Access Compliance Report

Public Rights-of-Way

(Pedestrian Signals)

Intersection ID: N/A	Main Street:	Cross Street: N/A	Location: N/A
ADA ID: EFE0751FCE4B	Signal Type: One Push Button-Non APS	Overall Compliance: No	Severity Score: BTN 1: N/A BTN 2: N/A No BTN: N/A
Codes/Mitigation Info/Possible Solution		Field Measurements/Component Compliance

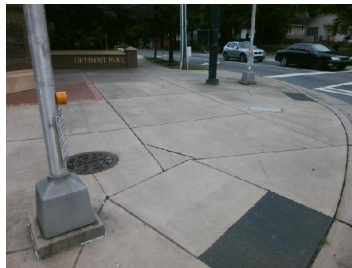
Possible Solutions: Provide Push Button Extension. Remove and Replace Clear Space.

PROW/ADA: R404.2, R404.3, R406.2
